On 31 March 1982 representatives of Florida Power & Light (FPL) and two cable manufacturers met with the ACRS Subcommittee on AC/DC Power Systems Reliability. The purpose of the meeting was to provide the ACRS subcommittee with FPL and industry experience with direct buried cable installations. The Class 1E underground system at St. Lucie Unit 1 is a direct buried installation.

The purpose of the ACRS subcommittee discussion was to determine whether, in light of existing data, a Tech Spec similar to the St. Lucie Unit 1 in situ cable performance monitoring specification (#4.8.1.1.3.b & .c) is necessary for the direct buried cable installation at St. Lucie. The consensus of the subcommittee was that in situ cable performance monitoring was not required. Accordingly we request that existing St. Lucie Unit 1 specifications #4.8.1.1.3.b & .c be deleted. The technical basis is provided below.

FIGURE 1

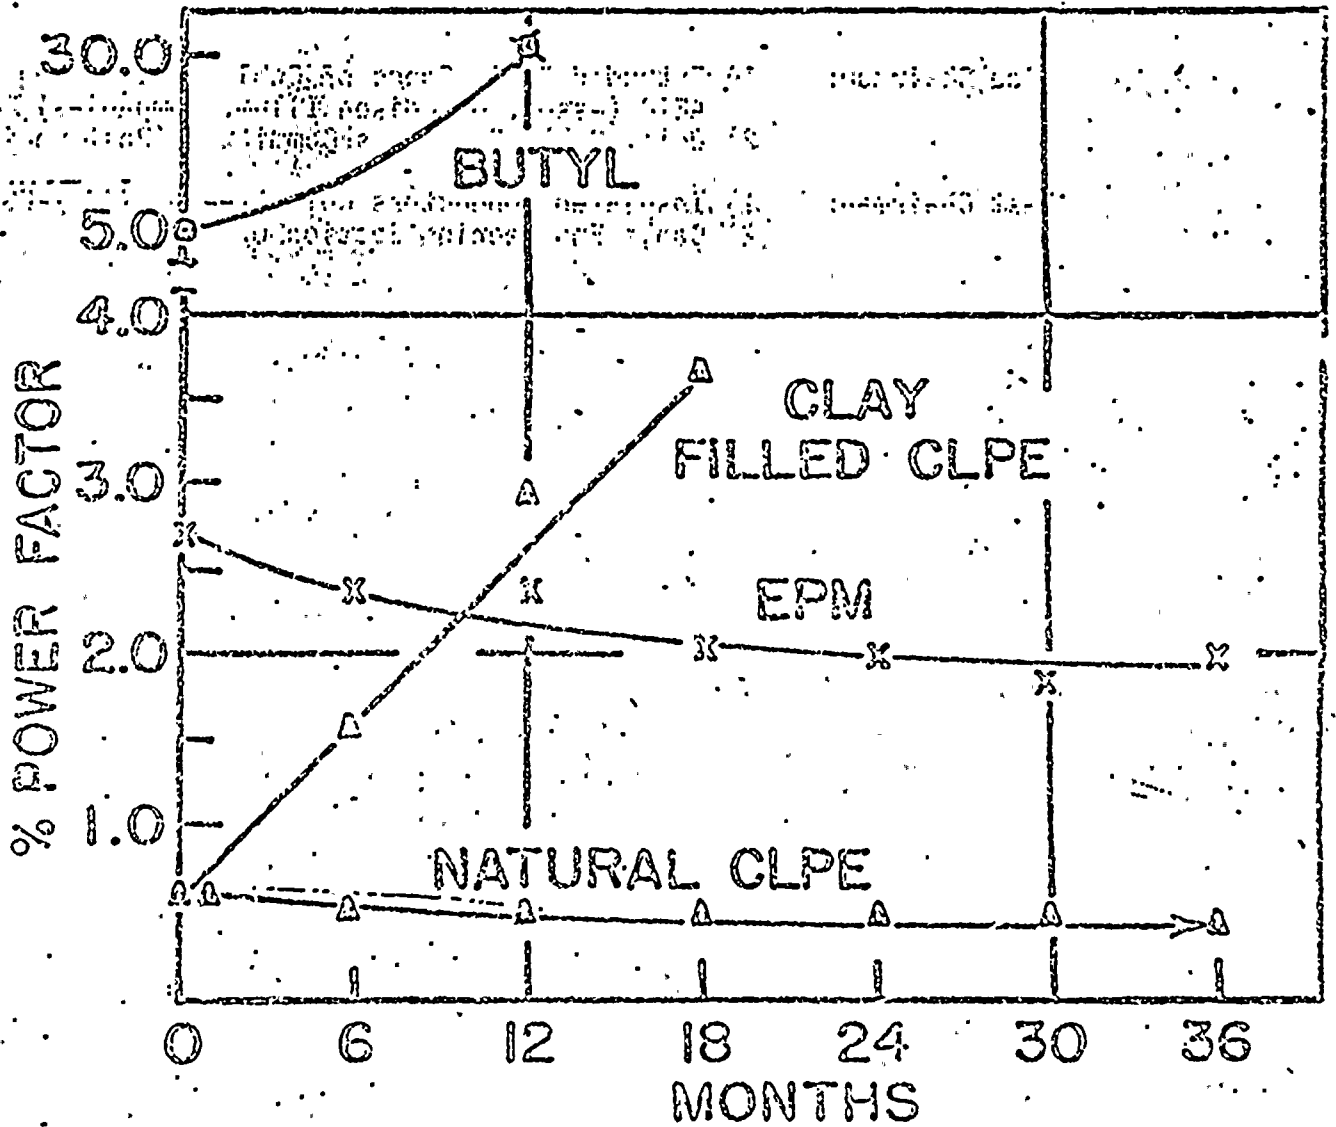
Accelerated tests allow one to compare one material with other materials. One typical example of such a test is illustrated by Figure 1. This has

been developed by one of the suppliers of the St. Lucie Unit 1 cables.

Note that the cable samples are short and have very small conductors. The thin walls of insulation magnify the effects of moisture. The 90°C water is another accelerator. Power factor is a term used by cable engineers to describe the amount of electrical leakage through a cable insulation. The crosslinked polyethylene has the lowest and most stable value. From this and large quantities of similar evaluations, crosslinked polyethylene is rated as a superior cable insulation for use in a wet environment. The EPR is also stable and has other properties that make it very acceptable. It must be noted that this is a very severe laboratory test since butyl has proven to be completely satisfactory in actual service, but "failed" this test in a short time.
